STATE OF NEW MEXICO ENERGY AND MINERALS DEPARTMENT OIL CONSERVATION DIVISION

We have reviewed your application dated August 20, 1985 for your proposed lined pond to be located in Section 20, Township 27 North, Range 19 West, NMPM, San Juan County, New Mexico. To continue with the review process, the following information and/or details must be resolved.

Re: SERH, Inc.
Water Disposal
Beautiful Mountain Field
San Juan County, N. M.

> Re: Application for a Lined Pond to be located in Unit O, Section 20, Township 27 North, Range 19 West, NMPM, San Juan County, New Mexico

Attach: Pit Sketch

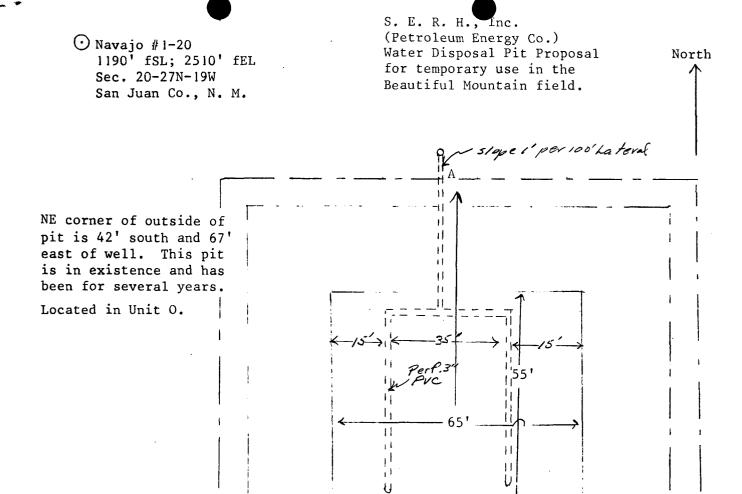
- 1. Please submit a schematic drawing showing relevant dimensions (e.g. berm thickness), the methods of anchoring the liner(s), vents, the leak detection system, and berm slopes.
- 2. The drawing of the pit included in your August 20 submittal shows only one line for your leak detection system and no laterals. This will not be considered acceptable. Please consult the Guidelines sent to you on August 14, 1985.
- 3. Unless it can be shown, through a hydrologic and site survey of the area, that no groundwater is at risk in the area, and that the natural soils are impermeable enough to allow fluid to be gathered by the leak detection system should a leak occur, a double liner system will probably be required.

I have taken a copy of the original sketch submitted on July 31, 1985 for obtaining approval for water disposal. On this sketch, I have penciled in the measurements and a change for the leak detection piping and how ORE, systems propose to anchor the pit liner.

Liner dimensions 136.5' X 127' 36 mil reinforced CPE material to be installed by ORE Systems, Farmington, New. Mexico. Anchored by cutting a trench 2' from inside top 18" deep and 18" or more wide and drop material in and cover. Estimated volume to ground level is 29,730 cft. or 5300 bbls.

S. E. A. H., Inc. Water Disposal Pit-Proposed for temporary use in the Beautiful Mountain Field.

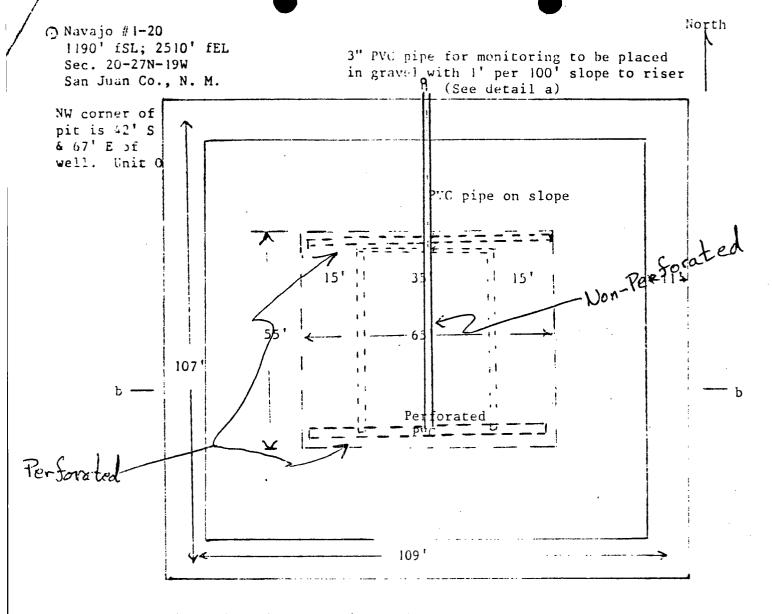
We have reviewed the plans and specifications in your application (WP-4) for the above-referenced lined evaporation pit. The design specifications submitted are acceptable and your application is hereby approved with the provisions that: a) the leak detection system design be modified to contain a non-perforated mainline running north-south, perforated laterals running east-west, and spaced as per the OCD "Guidelines"; and b) four vents are installed at mid-length of the berms to allow venting of any gases that may accumulate. It is my understanding that these provisions are acceptable to you as per your phone conversation of 10-7-85 with Mr. Philip Baca of the OCD. A copy of your schematic with the recommended changes shown in red is attached for your reference. A revised schematic is to be submitted to the OCD prior to installation of the leak detection system.

Liner dimensions 136.5' X 127' 36 mil reinforced CPE material to be installed by ORE Systems, Farmington, N. M.. Anchored in 18" X 18" trench 2' from inside top and covered. Estimated pit volume is 29,730 cft. or 5300 bbls.
